**Re: Applicant's Responses to CEC Staff Data Requests 58 through 78 and Workshop Queries 1 through 22, Humboldt Bay Repowering Project (06-AFC-07)**

**Responses to CEC Staff Data Requests  
58 through 78 and Workshop Queries 1 through 22**

**Humboldt Bay Repowering Project**

(06-AFC-7)

CLIENT	PACIFIC GAS & ELECTRIC	BY	WJP	FIGURE	2-A
LOCATION	HUMBOLDT BAY POWER PLANT	DATE	1/31/07	JOB NO.	6433.04
KING SALMON SHOULDER & ENTRANCE APRON			SCALE	1"=30'

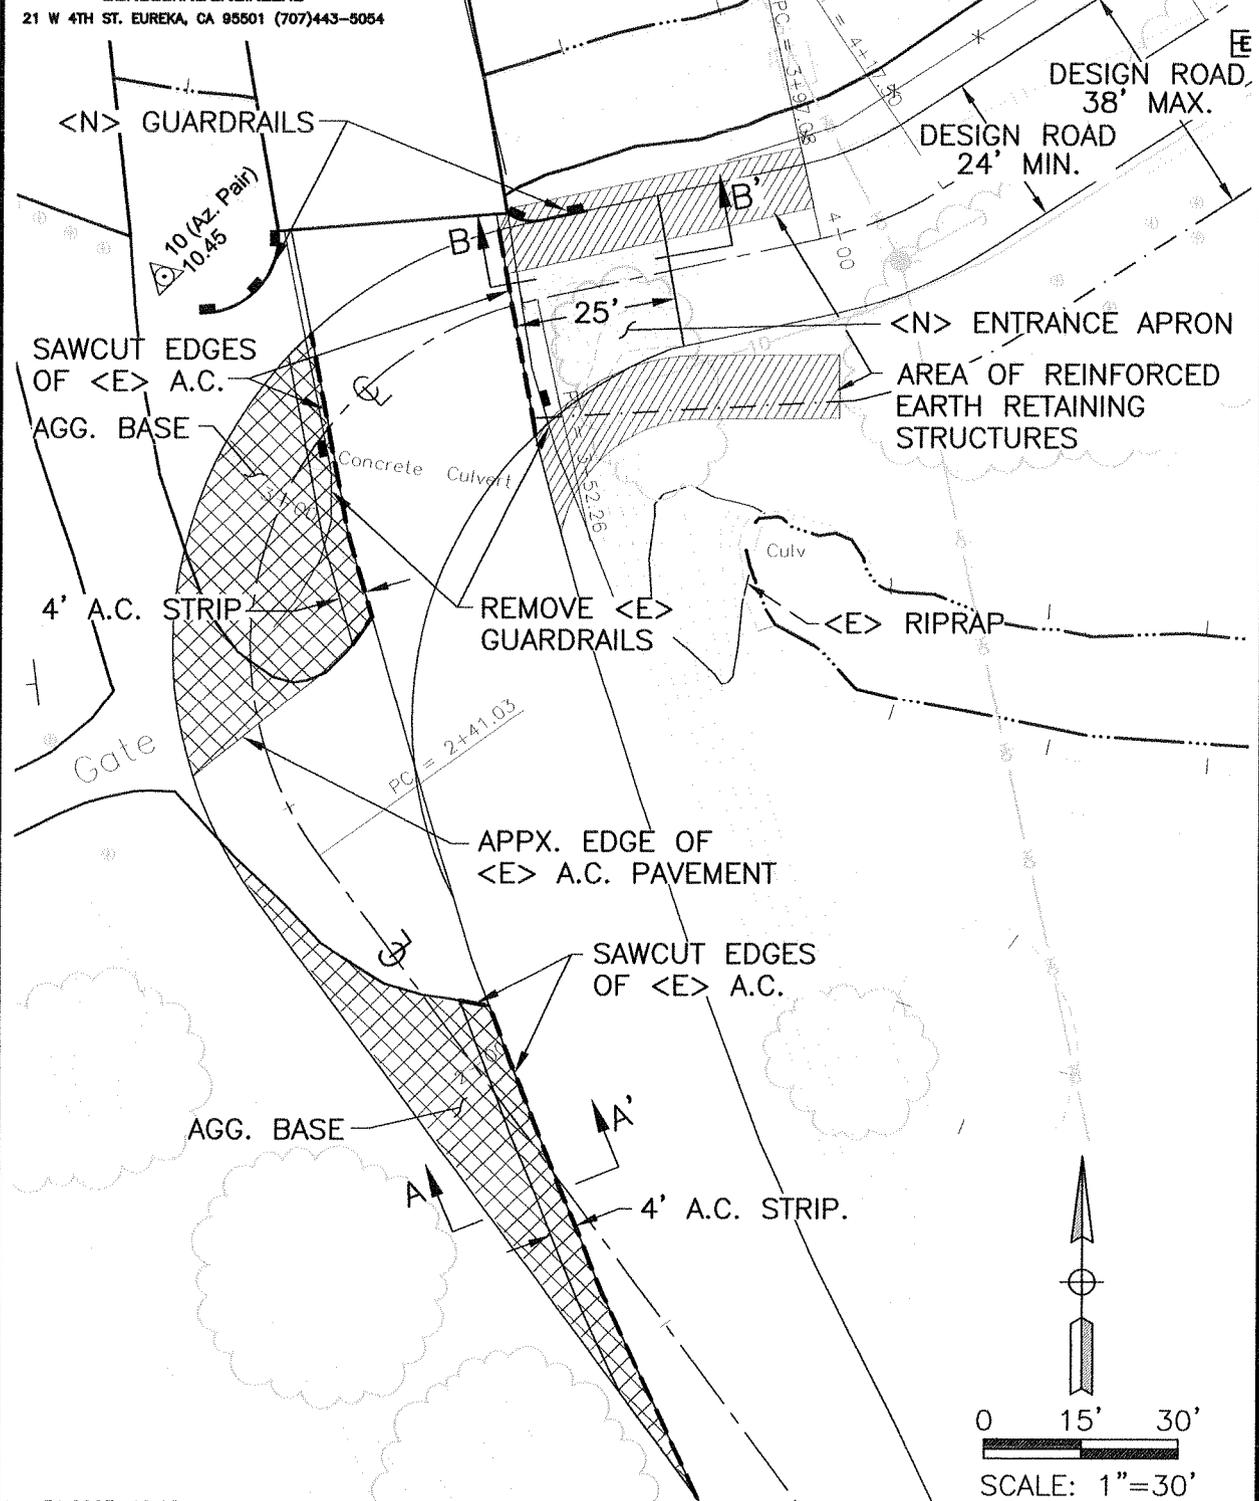
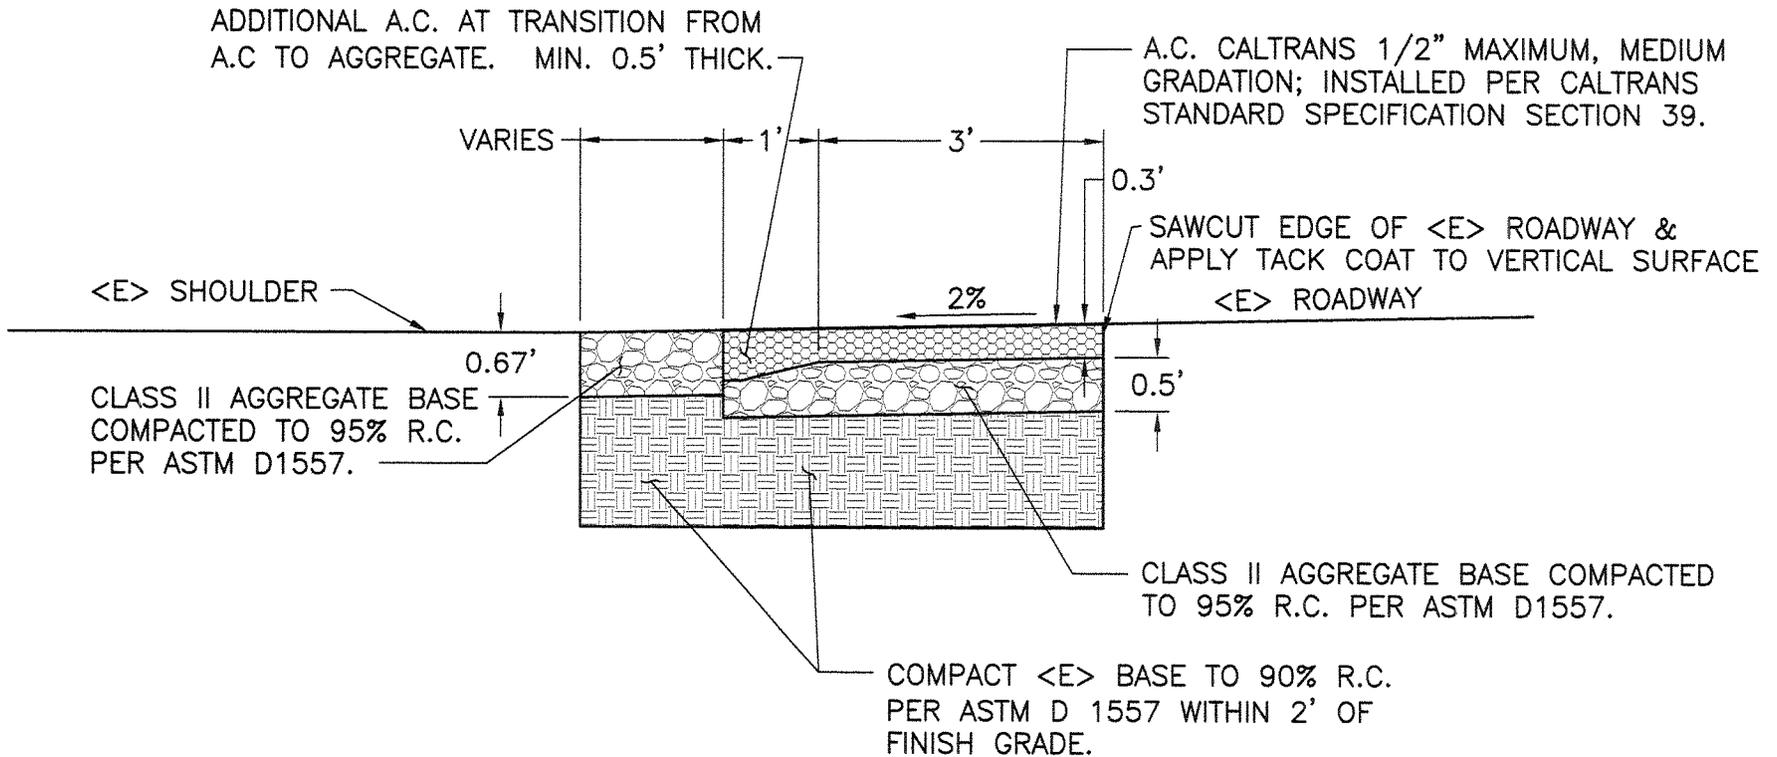
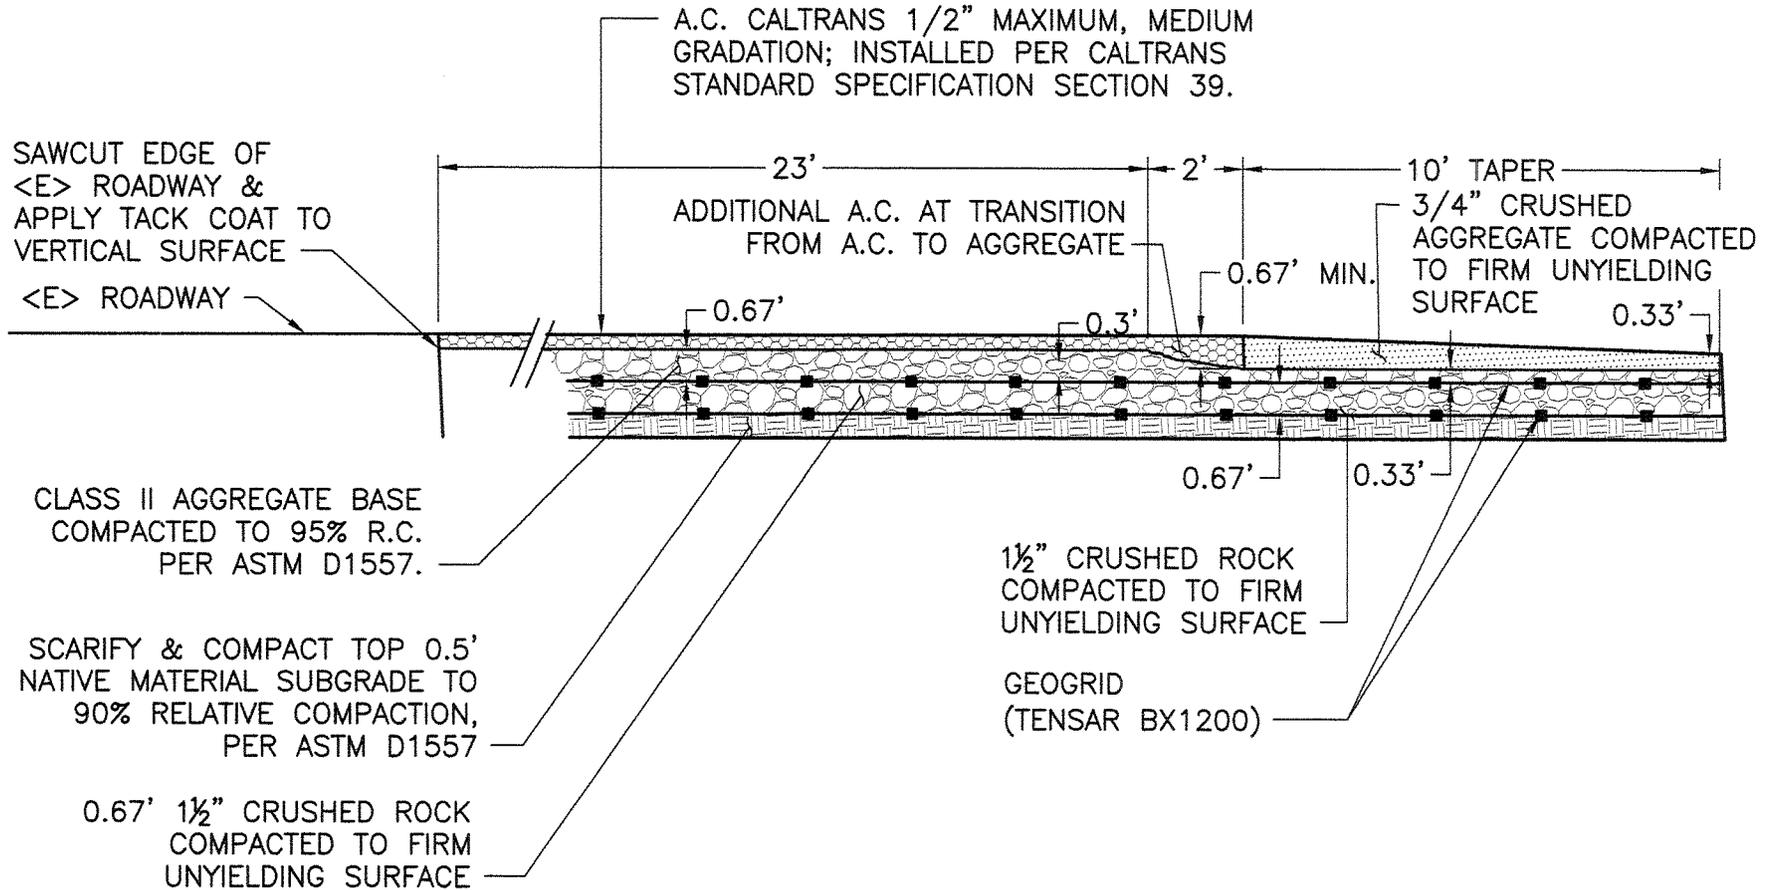
Attached is the figure we discussed on the phone. My question concerns the western shoulder of King Salmon Avenue and the entrance apron of the temporary road. What design requirements does Humboldt County require for these areas?

**FIGURE DR66-1**  
**EXISTING VIEW AND VISUAL SIMULATION**  
**FROM KING SALMON AVENUE - KOP2**  
 HUMBOLDT BAY REPOWERING PROJECT  
 HUMBOLDT COUNTY, CALIFORNIA

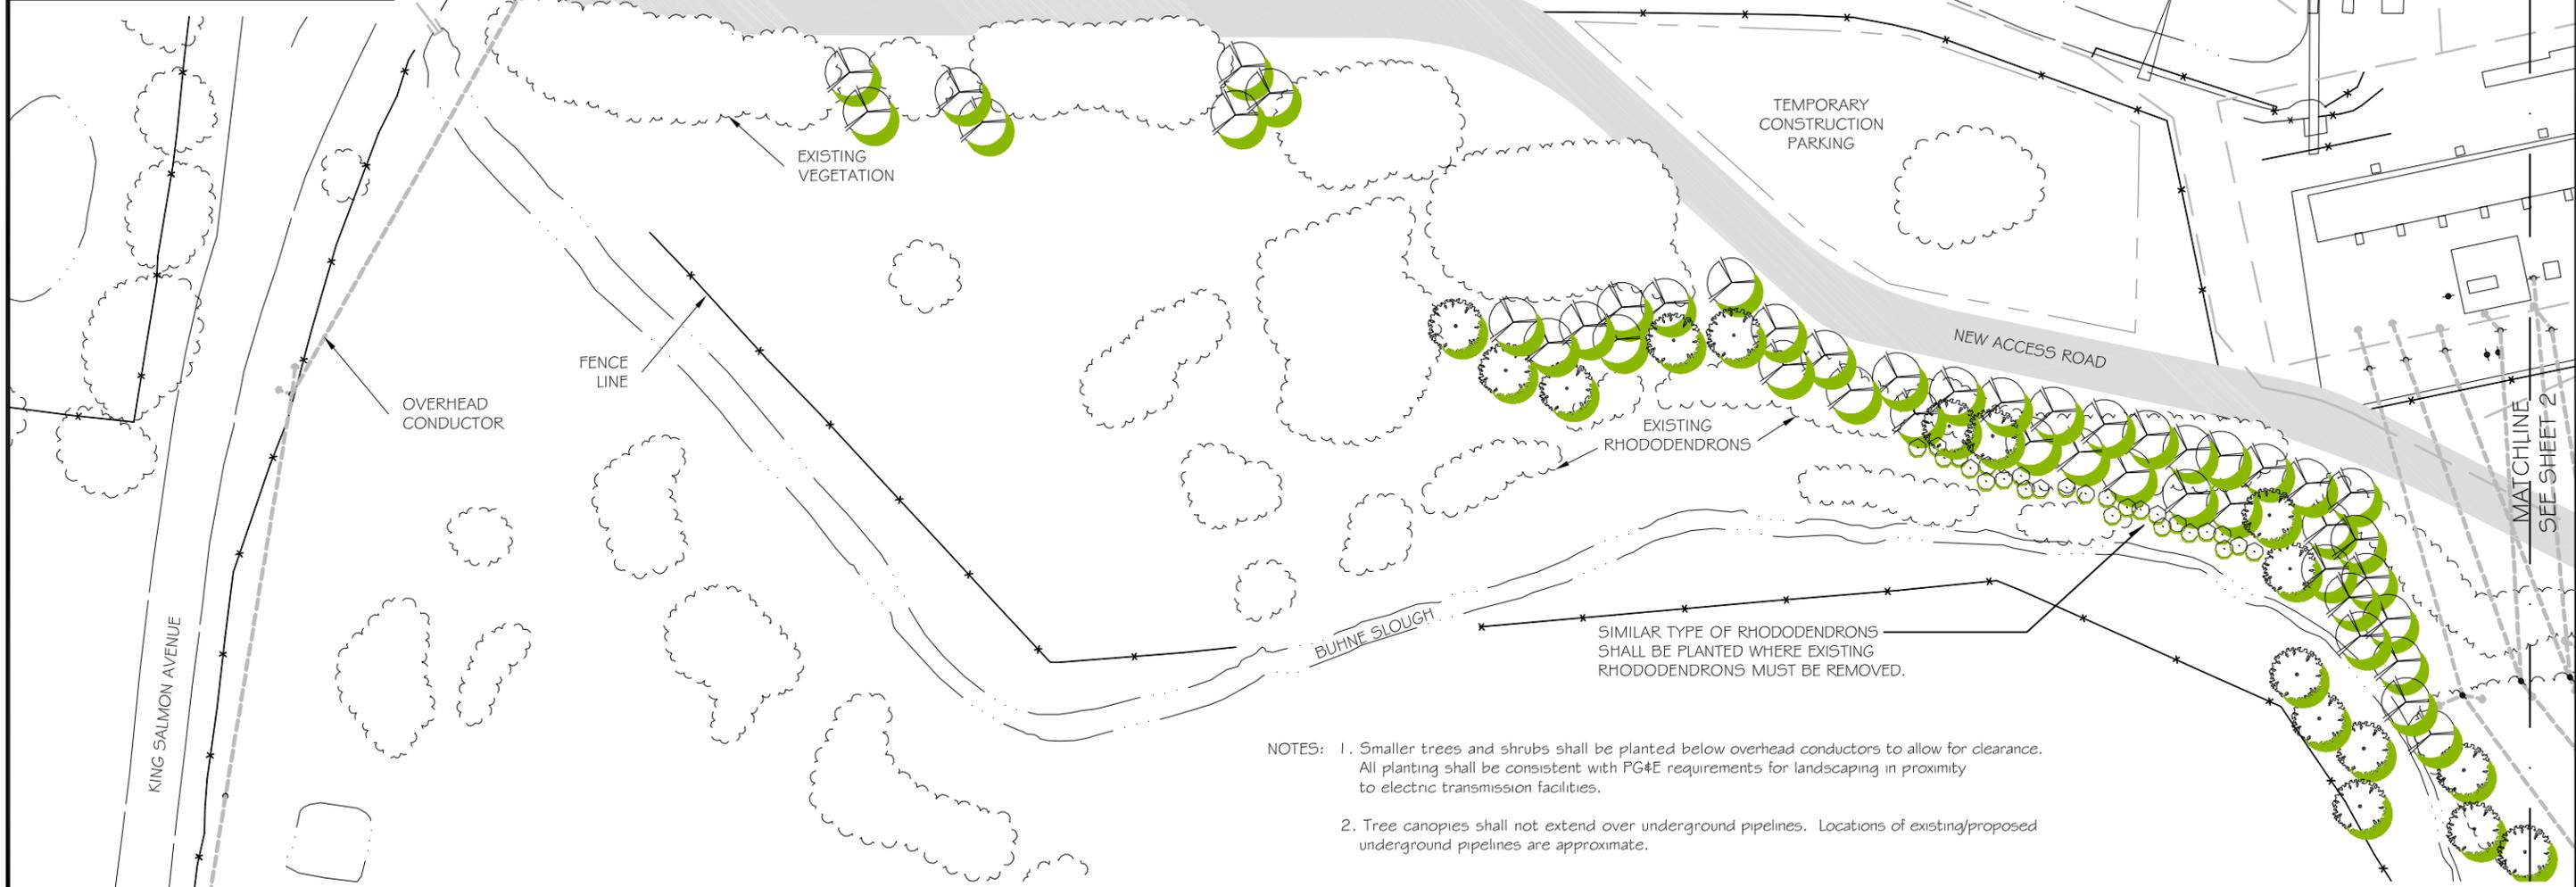
66. Please provide the following:

- (a) Figure DR66-1 shows the HBRP site as it would appear after Units 1, 2, and 3 have been demolished, and assuming 5 years of landscape screening growth. It is important to note that the schedule for the demolition of Units 1, 2, and 3 has not yet been determined.
- (b) The HBRP will involve the demolition of certain structures that must be removed to make room for the HBRP facilities. The demolition of Units 1 and 2 and the decommissioning of Unit 3 are not part of the HBRP project. The schedule for their demolition depends on several factors beyond the control of the HBRP project and will be determined through the NRC's decommissioning process.

**FIGURE WSQ21-1**  
**SAMPLE LOCATIONS**  
 PHASE II ENVIRONMENTAL SITE ASSESSMENT  
 HUMBOLDT BAY REPOWERING PROJECT

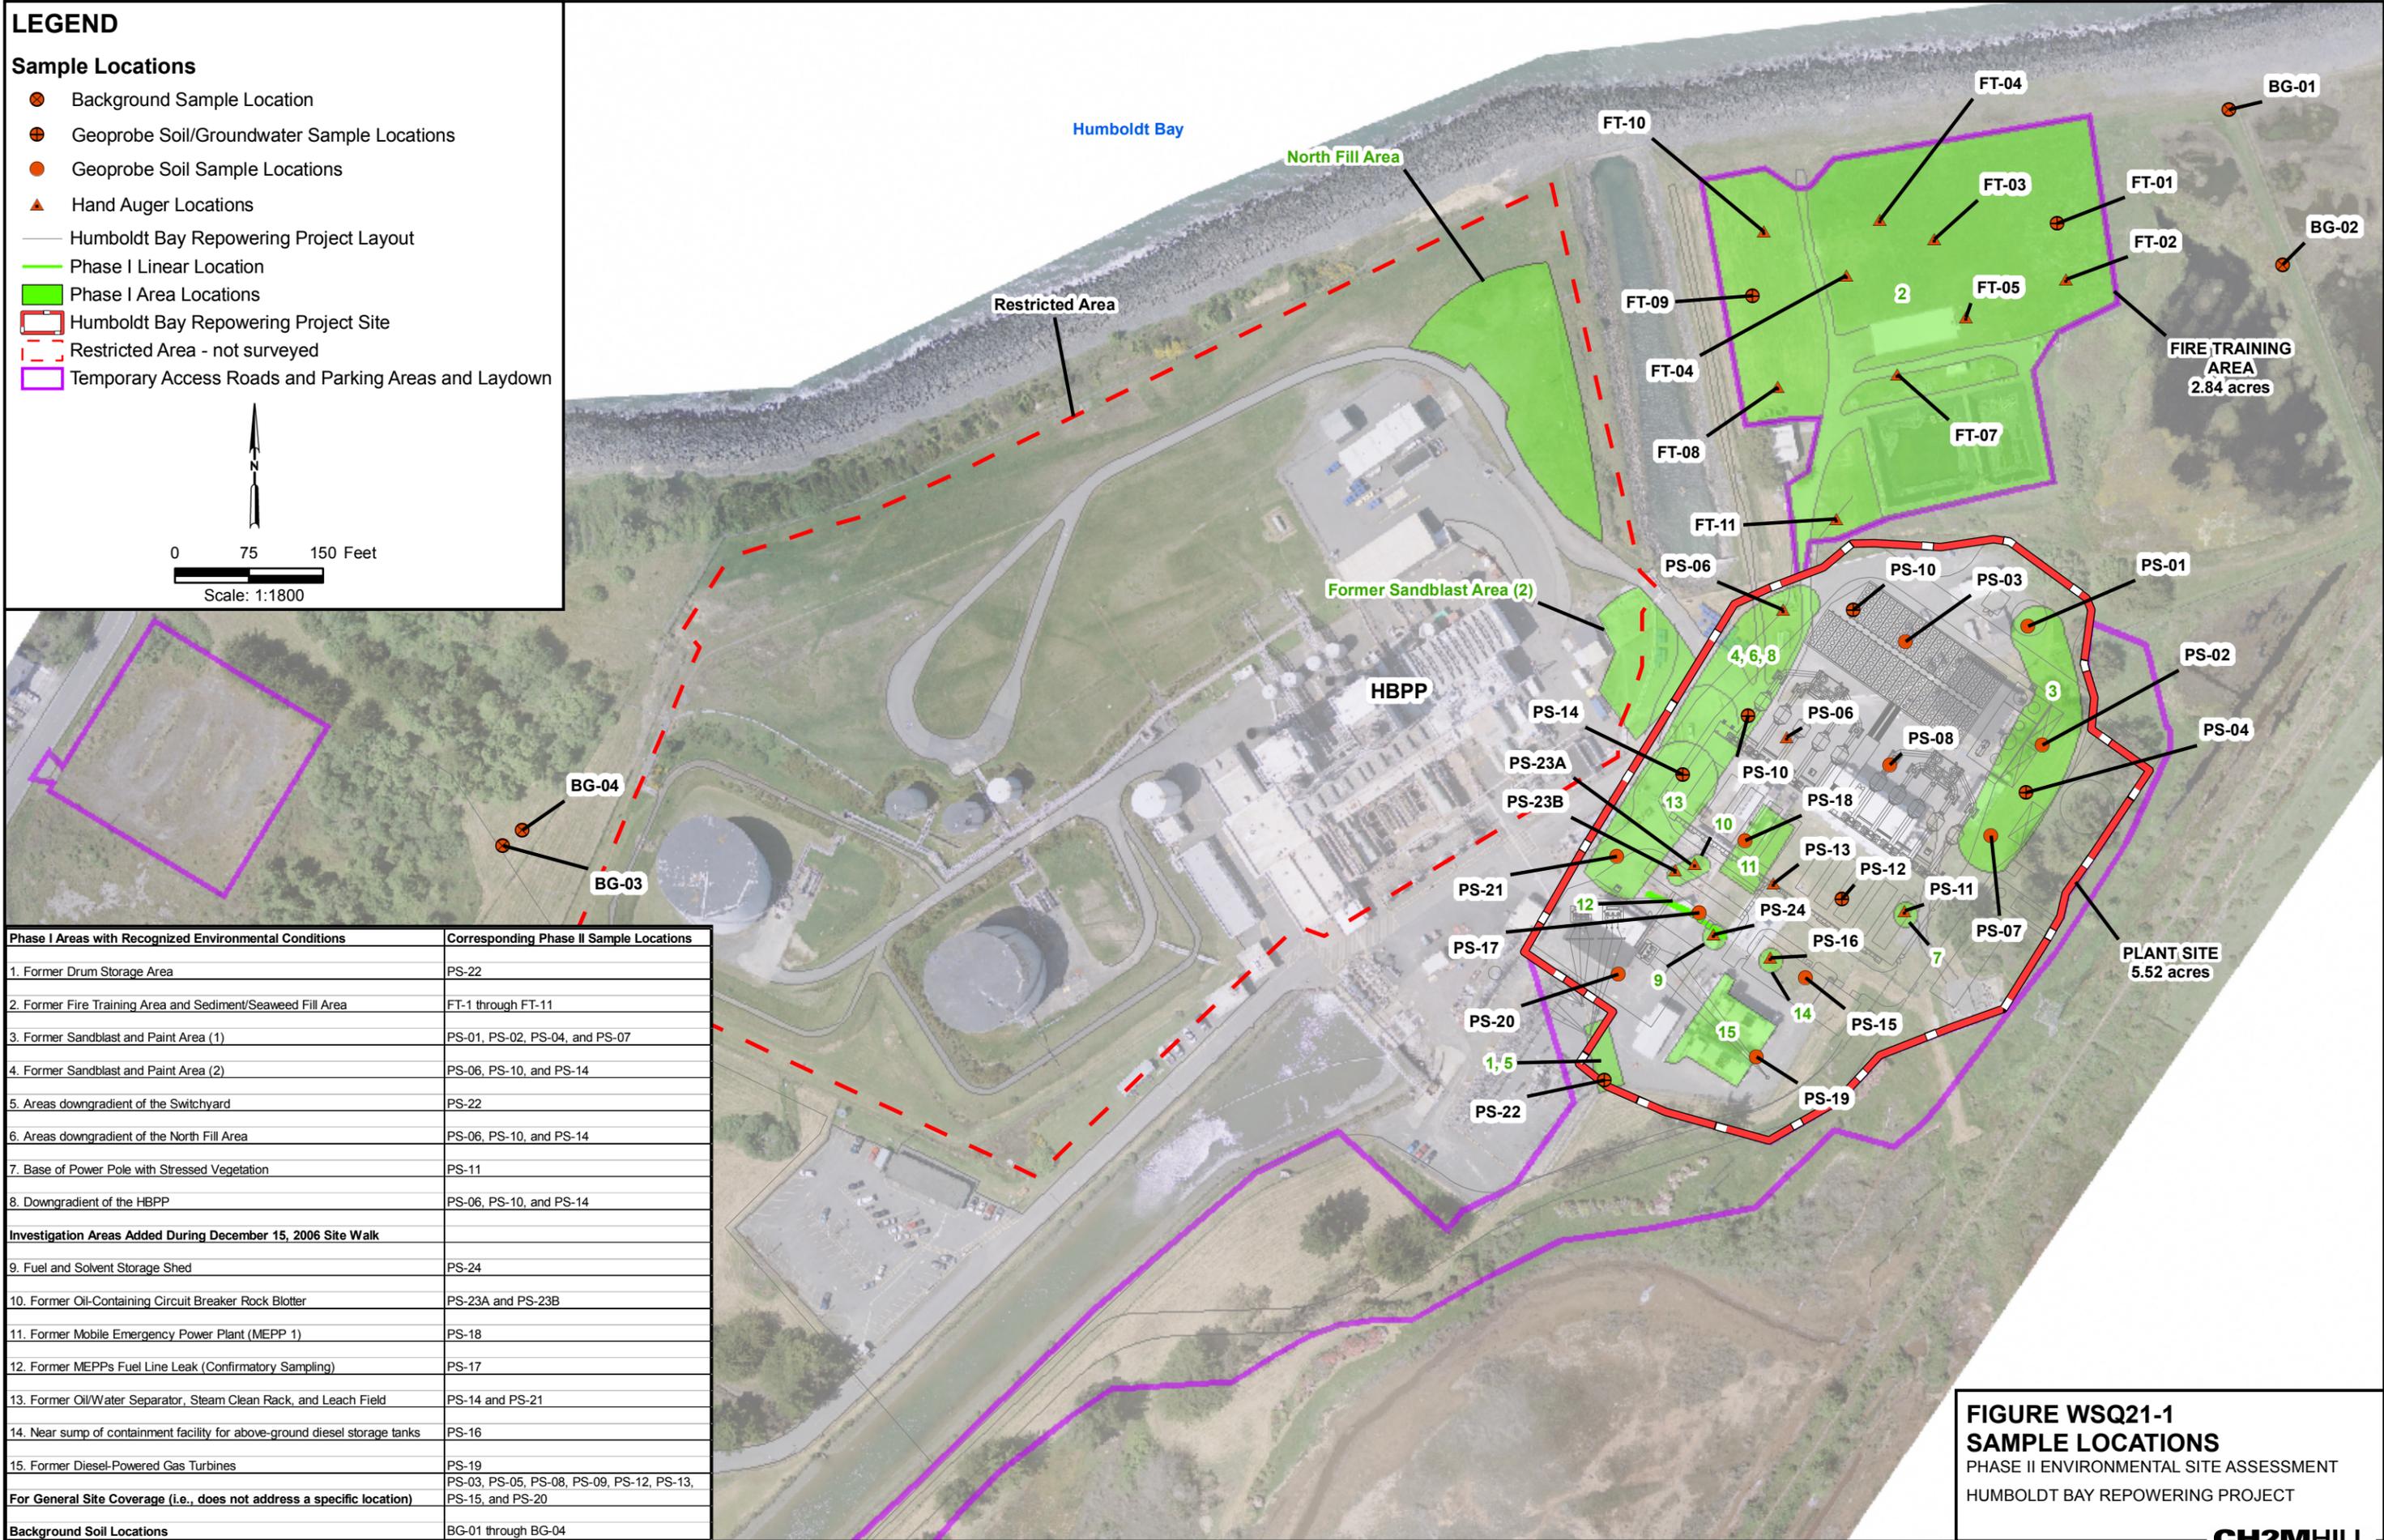
WSQ-21 *Please provide an updated map showing the eight areas of concern identified in the Phase I site assessment and the sampling locations for the Phase II site assessment.*

**Response:** Figure WSQ21-1 shows the Phase II Environmental Site Assessment sampling conditions, along with a table and labels indicating which samples were designed specifically to address areas of concern identified in the Phase I Environmental Site Assessment.
